# Access Compliance Report

## Public Rights-of-Way

### (Curb Ramps)

Intersection ID: 3539	Main Street: HARRIS_CORNERS_PY	Cross Street: MAPLE_VIEW_LN	Location: NE
ADA ID: 7B8EB7EB06F4	Ramp Type: Perp	Initial Pass/Fail: Fail	Overall Compliance: No
			Severity Score: 21.25

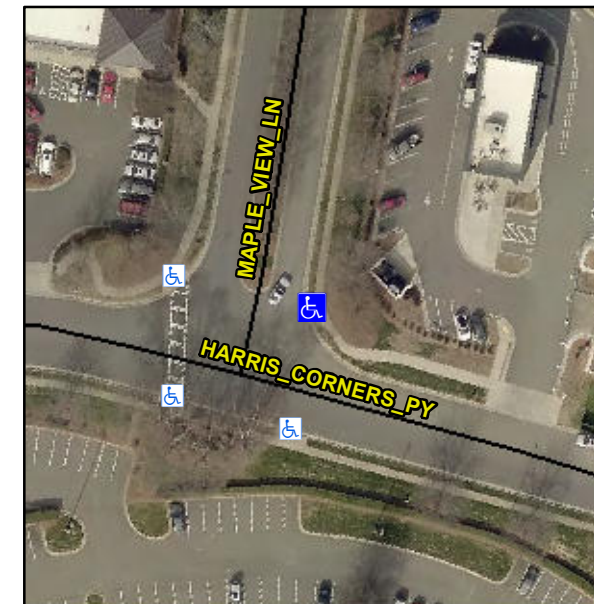
**R304.5.1, R304.2.2**

Compliance	Description	Data	Compliance	Description	Data
N/A	Ramp Length (in)	40.0	No	Ramp Slope (%)	11.9
No	Ramp Width (in)	47.0	Yes	Ramp XSlope (%)	0.1
N/A	Flare Type LT	N/A	N/A	Flare Type RT	N/A
N/A	Flare Slope LT (%)	N/A	N/A	Flare Slope RT (%)	N/A
N/A	Flare Traversable LT?	N/A	N/A	Flare Traversable RT?	N/A
N/A	Landing Length (in)	N/A	N/A	DWS Provided?	N/A
N/A	Landing Width (in)	N/A	N/A	DWS Contrast?	N/A
N/A	Landing Slope (%)	N/A	N/A	DWS Length (in)	N/A
N/A	Landing X Slope (%)	N/A	N/A	DWS Full Width?	N/A
N/A	Landing Curb? (Y/N)	N/A	N/A	DWS Offset (in)	N/A
N/A	Shared Landing?	N/A			
N/A	Gutter Ponding?	N/A	N/A	Gutter Slope (%)	N/A
N/A	Gutter Lip Ht (in)	N/A	N/A	Gutter X Slope (%)	N/A
N/A	Painted X Walk1?	No	N/A	Painted X Walk2?	N/A
	X Walk 1 Direction	To NW		X Walk 2 Direction	N/A
N/A	X Walk 1 Width (in)	N/A	N/A	X Walk 2 Width (in)	N/A
	X Walk 1 Slope (%)	7.4		X Walk 2 Slope (%)	N/A
	X Walk 1 X Slope (%)	0.2		X Walk 2 X Slope (%)	N/A

**Remove & Replace Entire Ramp.**
